UNITED STATES PATENT AND TRADEMARK OFFICE

APPLICATION NO.	FILING DATE	FIRST NAMED INVENTOR	ATTORNEY DOCKET NO.	CONFIRMATION NO.
09/761,375	01/16/2001	Terry N. Williams	11675.163.2	5328

Office Action Summary

DETAILED ACTION

FIG. 40

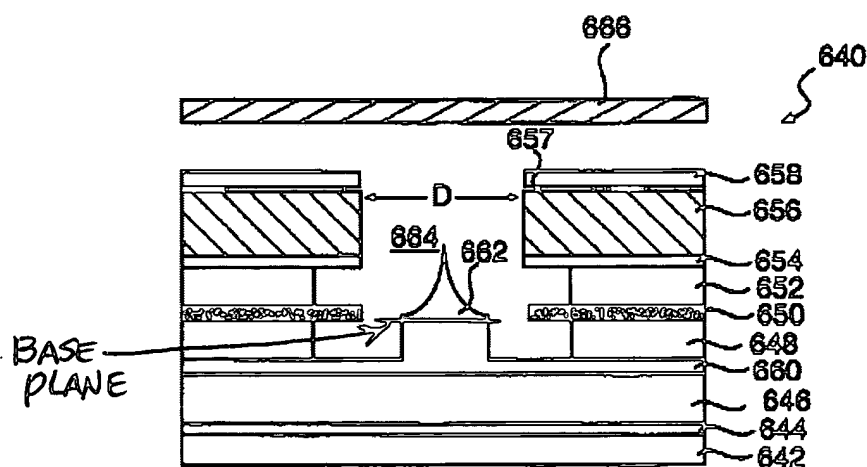
8. With respect to claims 9, 12, 15, and 20, Jones et al. disclose a field emission device comprising a substrate (Fig. 40, 642 & 644); a cathode conductive layer (646) disposed over the substrate; and a monolithic emitter tip (662) integral with and etched entirely from an emitter layer (660) disposed over the cathode conductive layer and having a base plane adjacent to the emitter layer, an apex, and a continuously concave exterior surface extending from the base plane to the apex. Jones et al. also disclose: the exterior surface having a substantially paraboloid vertical profile that extends from the base plane to the apex; and the exterior surface having an ovoid profile that extends from the base plane to the apex. Jones et al. also disclose the emitter tip and the single emitter layer are formed of a single material (column 24, lines 62-65). In Figure 40, Jones et al. also disclose a conductive gate structure (656 & 658) disposed over the

cathode conductive layer (646), an array of apertures (664) formed through the conductive gate structure, each of the emitter tips (662) being exposed through one of the apertures; and an anode panel (666) for emitting light in response to electrons emitted from the array of emitter tips.

9. With respect to claim 18, Jones et al. disclose a field emission device comprising an emitter tip (662) formed from an emitter layer (660), the emitter tip having a height and including a base plane and an apex, wherein the emitter tip is generally conical and has a substantially rectilinear profile between the base plane and the apex, and wherein the emitter tip and the single emitter layer are formed of a single material (column 24, lines 62-65).

10. With respect to claims 10, 13, and 16, Jones et al. disclose a conductive gate structure (Fig. 40, 656 & 658) disposed over the cathode conductive layer (646); an aperture (664) through the conductive gate structure, the emitter tip (662) being

exposed within the aperture, and an anode panel (666) positioned over the conductive gate structure and the emitter tip.

13. With respect to claims 11, 14, and 17, Jones et al. disclose an anode conductive layer (Fig. 40, 666), and a phospholuminescent panel for emitting light upon being excited by electrons (column 10, lines 33-39). Jones et al. do not disclose a transparent panel. However, it would have been obvious to one of ordinary skill in the art to modify the Jones et al. invention and have a transparent panel to provide image output capability of the display device.
